**Meeting Date:** Thursday 14 March 2019  
**Location:** Council Chambers, Level 1A, 1 Pope Street, Ryde  
**Time:** 5.00pm

### **2 17 SHUMACK STREET, NORTH RYDE - DEMOLITION OF STRUCTURES AND CONSTRUCTION OF AN ATTACHED DUAL OCCUPANCY WITH PARKING - LDA2018/0348**

### **City of Ryde Local Planning Panel Report**

<b>DA Number</b>	<b>LDA2018/348</b>
<b>Site Address &amp; Ward</b>	<b>17 Schumack Street, North Ryde – East Ward</b>
<b>Zoning</b>	<b>R2 Low Density Residential</b>
<b>Proposal</b>	<b>Demolition of structures and construction of an attached dual occupancy with parking</b>
<b>Property Owner</b>	<b>Limin Li</b>
<b>Applicant</b>	<b>ARC Homes</b>
<b>Report Author</b>	<b>Natalie Camilleri – Senior Town Planner</b>
<b>Lodgement Date</b>	<b>4 September 2018</b>
<b>No. of Submissions</b>	<b>Five (5) submissions</b>
<b>Cost of Works</b>	<b>\$800,000.00</b>
<b>Reason for Referral to LPP</b>	Development that contravenes a development standard imposed by an environmental planning instrument by more than 10% or non-numerical development standards.

Figure 12: Dwelling 1 first floor balcony side setback encroachment

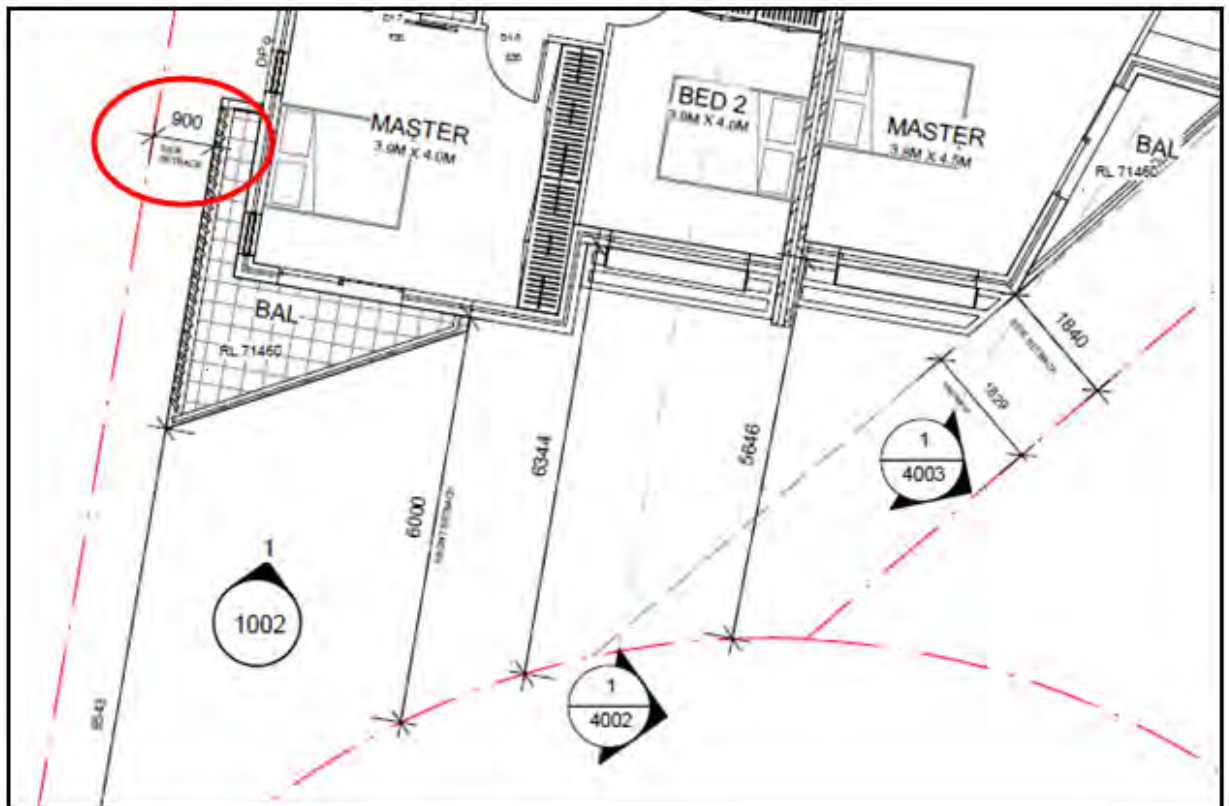
Side setbacks are crucial in ensuring suitable separation between dwellings is provided for fire safety, privacy, light and air. The RDCP 2014 stipulates that the outside walls of a two storey dwelling are to be set back from side boundaries not less than 1.5 metres. Setbacks are measured at 90 degrees to the allotment boundary and are measured to the outer most edge of the building elevation including balconies, terraces and porches. In this regard, Dwelling 1 provides a side setback of 1.5m to the outer wall, but only 900mm to the 1<sup>st</sup> floor balcony, which is located off the main bedroom which is shown in Figure 12. It is considered that as the balcony only services a bedroom, its size is excessive, and there is no reason why it cannot comply. If the application was to be recommended for approval, a condition of consent would be required to ensure the balcony was setback 1.5m from the side boundary.

**Figure 13: Stair encroachment into the garage of Dwelling 2**

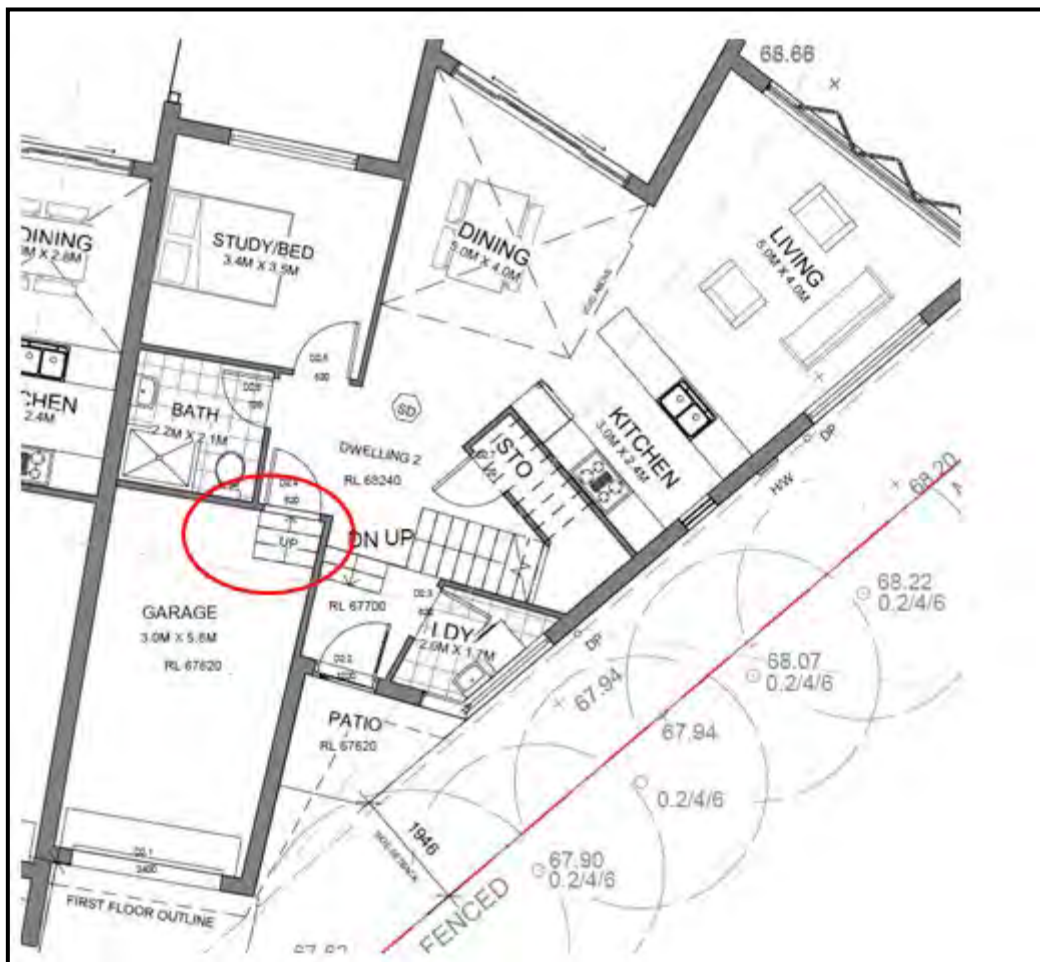
- The maximum width of the garage is 6 metres or 50% of the frontage. The external width is 6.24m.
- Garages must be located behind the building line and be setback 1m from the facade, however the garage of Dwelling 2 projects forward of the building line.
- The minimum internal garage dimensions do not comply. In this regard, the minimum single garage dimensions are 3m x 5.4m. The garage of dwelling 2 provides the minimum dimensions, however the internal stairs leading into the dwelling encroaches the minimum parking area as shown in Figure 13.

It is considered that these non-compliances are unacceptable because the projection of the garages does not allow them to be integrated with the overall design, and as a result, the visual impacts of car parking structures within the streetscape are unacceptable.

**Figure 14: Living area within Dwelling 2 – potential for north facing window circled in red**

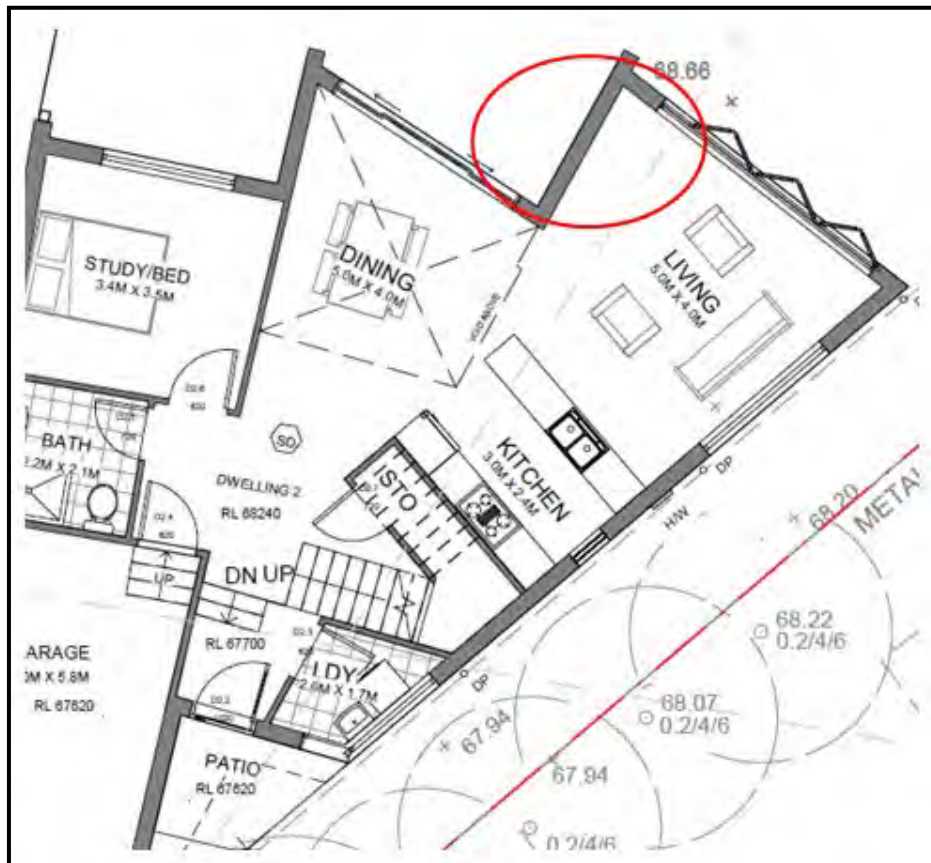
The living area of Dwelling 2 has windows facing both east and south, however there is the potential for a north facing window to be provided as shown in Figure 14. This could be addressed as a condition of consent if the application was to be approved.

**Figure 15: Dwelling 2 – Master bedroom balcony posing overlooking concerns to adjoining site.**

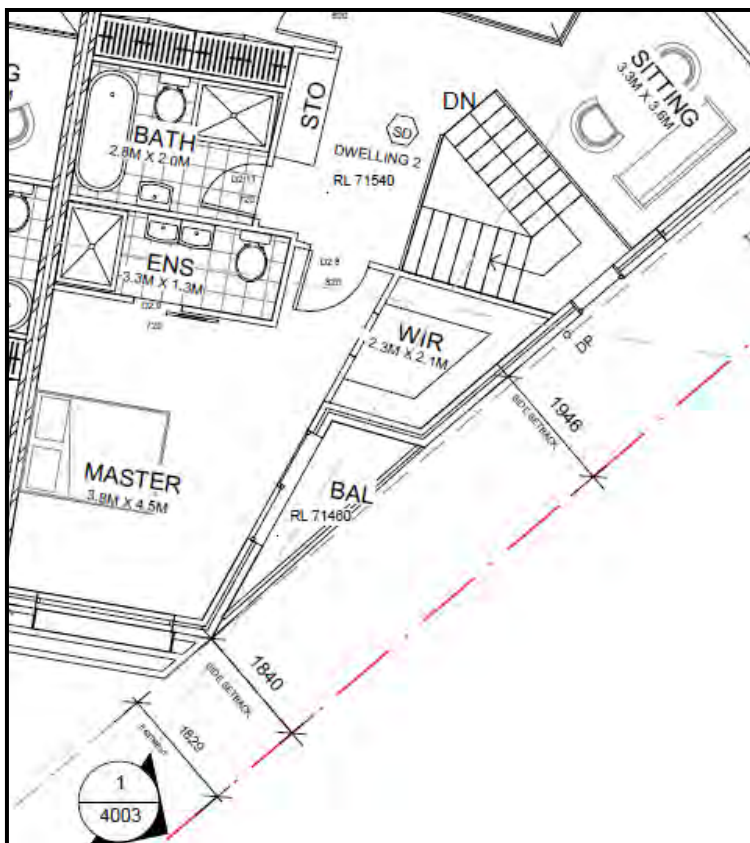
The balcony off the master bedroom within Dwelling 2 faces the eastern side boundary, which poses privacy and overlooking concerns to the adjoining site along the southern boundary (see Figure 15), therefore this balcony not supported.

**Figure 11:** Extract of Survey showing site width at arc (Source: Higgins Surveyors).

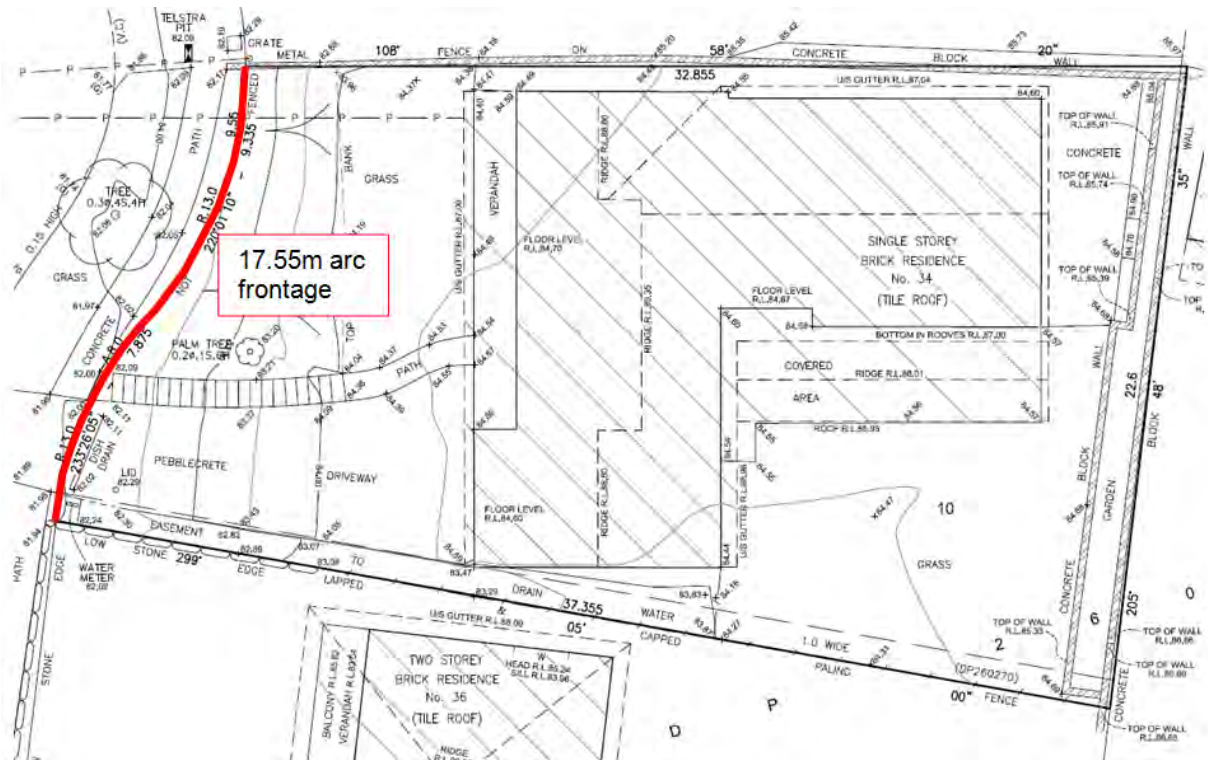
This variation is not supported as approval of the development would adversely impact upon the established character of the local area, would create an undesirable precedent for future development to occur within the LGA due to an erosion of the Standard and would therefore not be in the public interest.

**Figure 13:** Site plan with annotated site widths demonstrating width at building line.

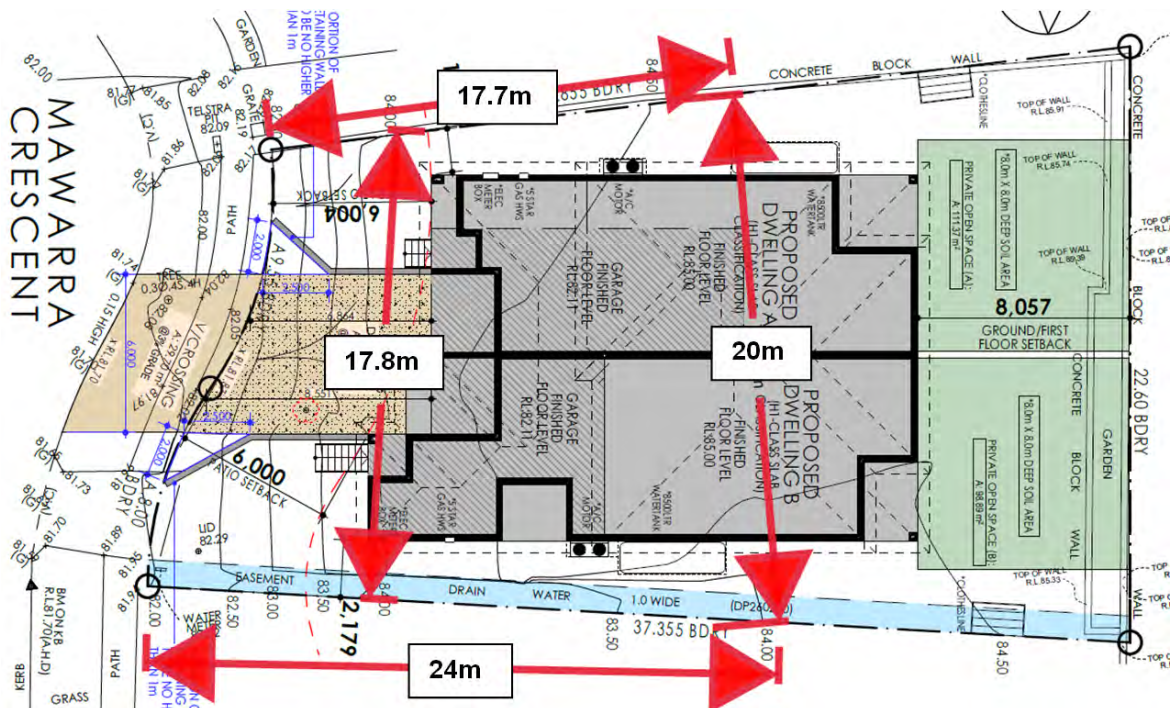
Whilst it is noted that the site eventually broadens to 20m, this statement does not consider that the proposed dual occupancy is setback 6m from the front boundary, at which point the site width is approximately 17.8m, representing a variation of 11% from the development standard (see **Figure 13** below).

The applicant’s argument that the development standard is considered to be unreasonable and unnecessary because the site widens to 20m mid-block fails, as this approach does not take into account the impact of the proposal in regard to the local character. The variation to the development standard results in an inappropriate design that is not consistent with the intended character of the locality.

**Figure 14:** Extract from site plan showing extent of retaining walls in front setback.

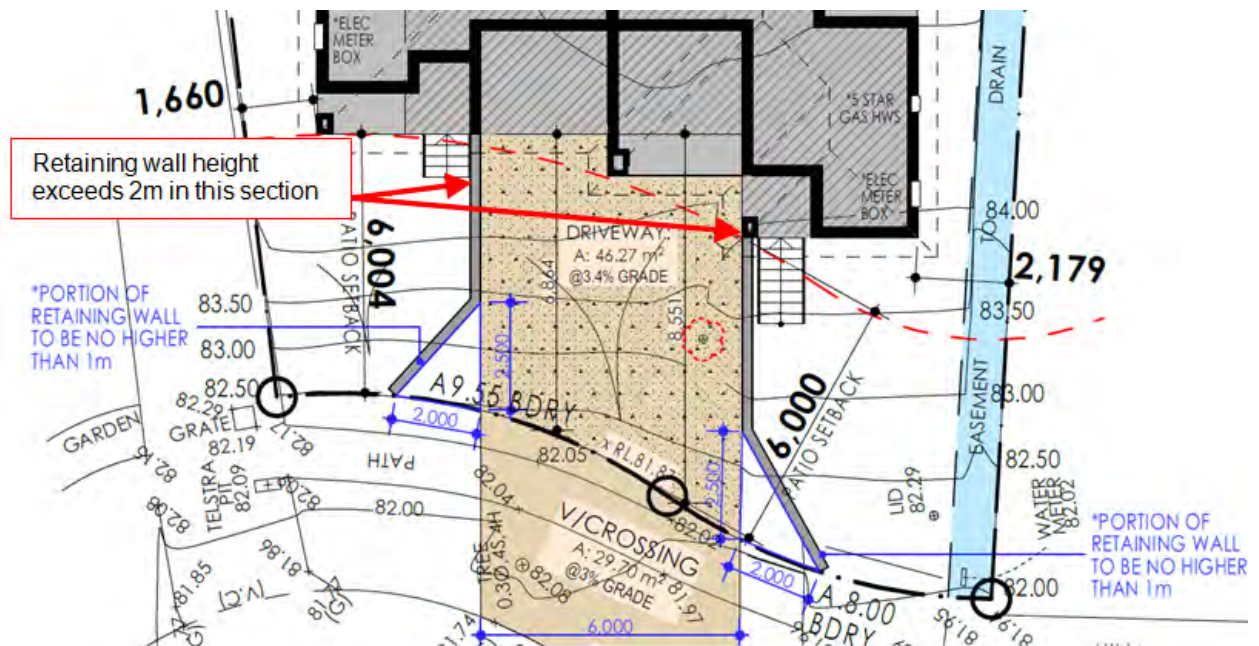
The application proposes excavation of approximately 2.3m within the building footprint to facilitate the semi-basement garage. In order to achieve a driveway with an appropriate grade and design to the garages, excavation within the front setback (i.e. outside the building footprint) appears to be approximately 2m. Retaining walls with a height of up to 2.3m are required to facilitate the proposed excavation, as shown in **Figure 14** below.

The excavation and resulting retaining walls create inconsistency along the streetscape.

**Figure 15:** Extract from landscape plan showing extent of hard paving within front setback

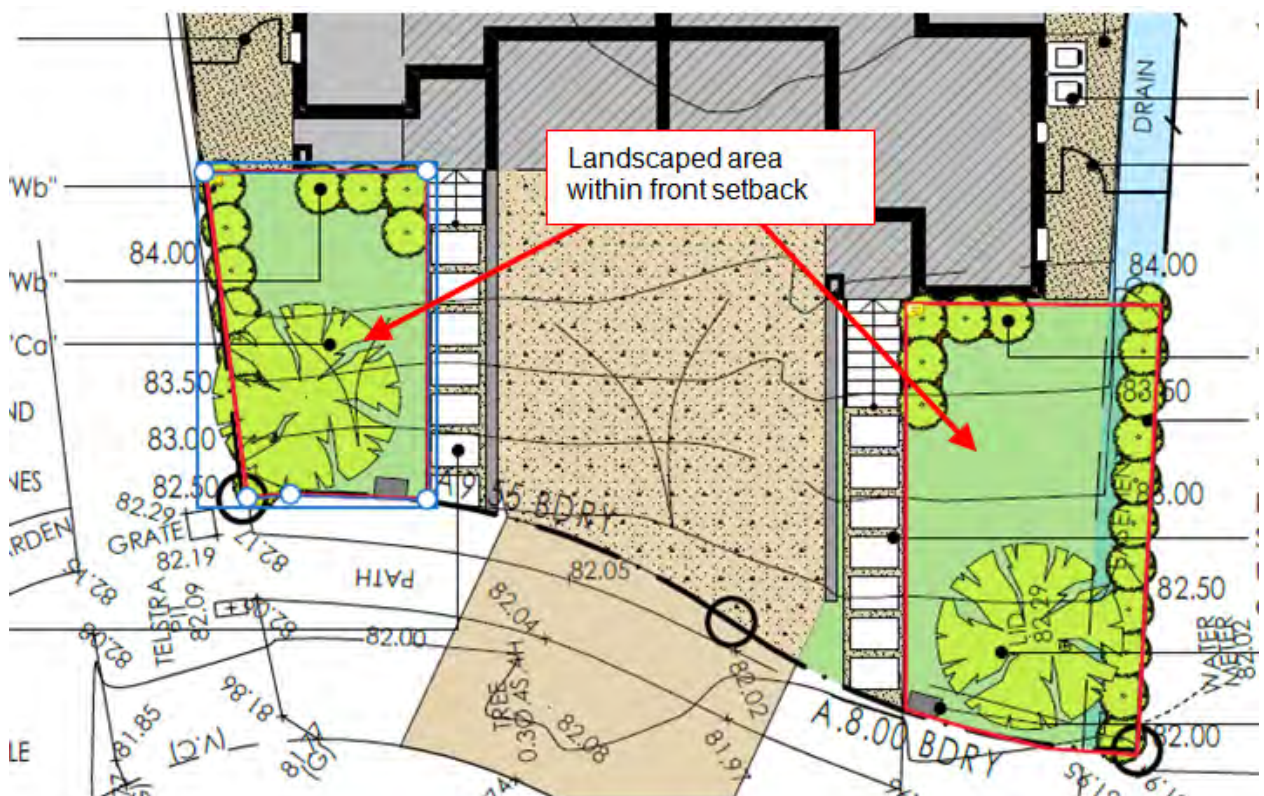
Section 2.13 (e) requires hard paving areas in the front setback to be minimised, being no more than 40% of the front setback area. This application proposes hard paving of approximately 62m<sup>2</sup> within the front setback (see **Figure 15** below), which has a total area of 121m<sup>2</sup> (i.e. 51% hard paving).

The landscape plan (see **Figure 15**) is also not consistent with the amended architectural plans, which have a splay in the retaining walls to provide sight distances for vehicular access. The splay would further reduce the amount of landscaped area provided in the front setback.

**Figure 16:** Extract of Ground Floor Plan showing north western facing living area windows.

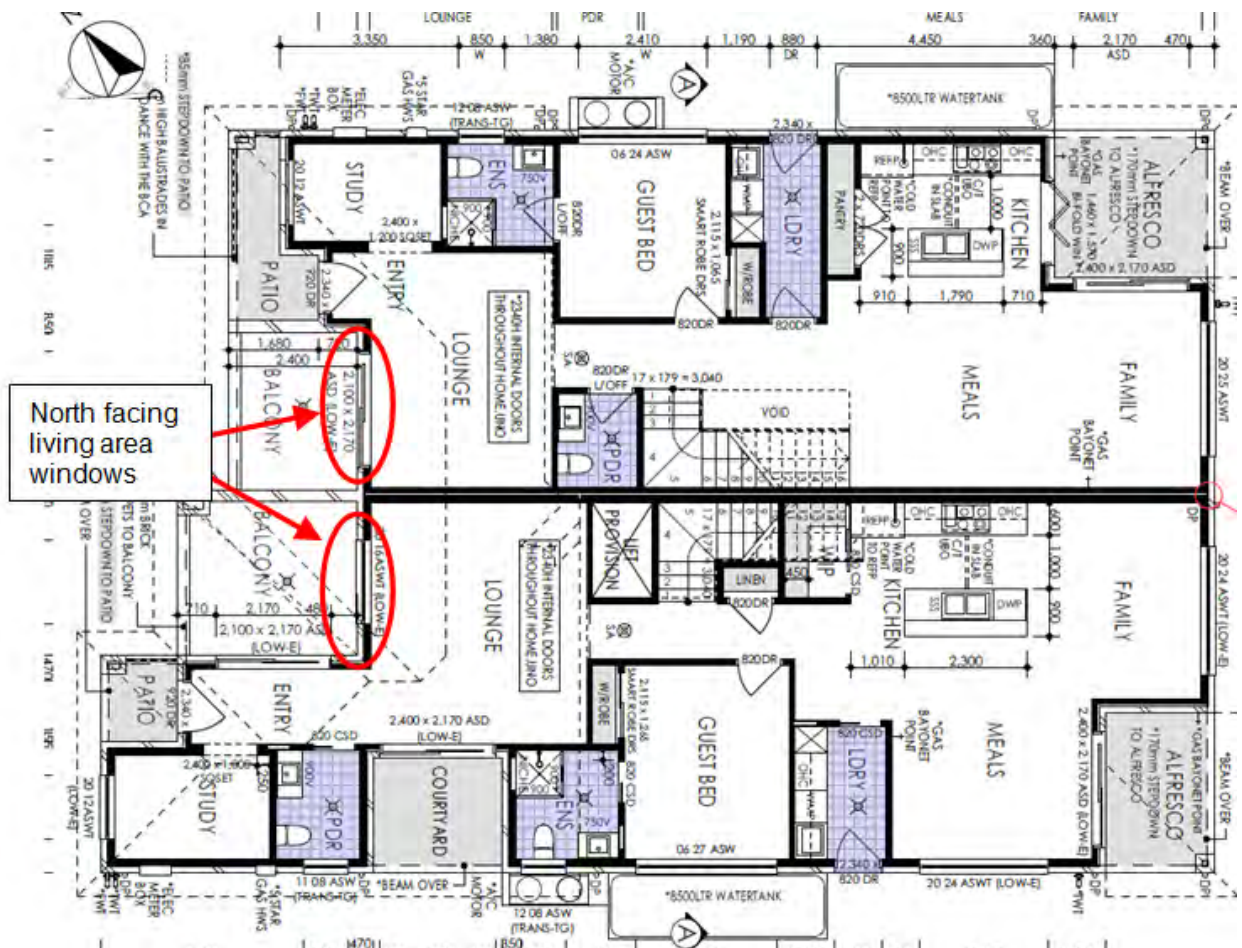
Section 2.14.1 (c) of the RDCP 2014 requires windows of north-facing living areas of subject dwellings to receive at least 3 hours sunlight between 9am and 3pm on June 21. **Figure 16** shows the north facing windows of the front lounge room being recessed due to the proposed balconies on the front elevation.

Given the orientation of the family/living area at the rear of the site is south-facing, the importance of adequate solar access to the front lounge/living room is significant to ensure the dwellings have sufficient amenity. The applicant has failed to demonstrate that three hours sunlight is provided to a portion of the surface of these windows on June 21, and therefore, the dwellings are considered to have poor amenity for future occupants.

**Figure 12:** Extract from Site Plan showing rear setback to eastern boundary.

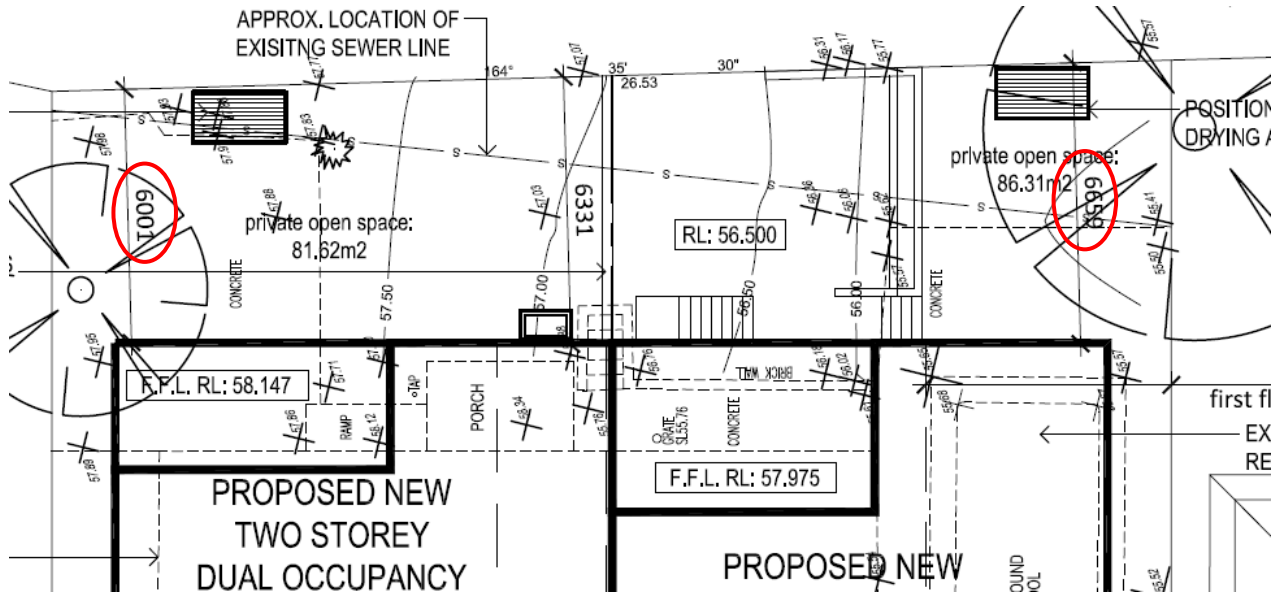
The proposal has a rear setback ranging between 6m and 6.659m, as shown in **Figure 12**.

The proposal is therefore non-compliant with this control, varying from the control by 2.89m (33%). This non-compliance is considered acceptable in this instance for the following reasons:
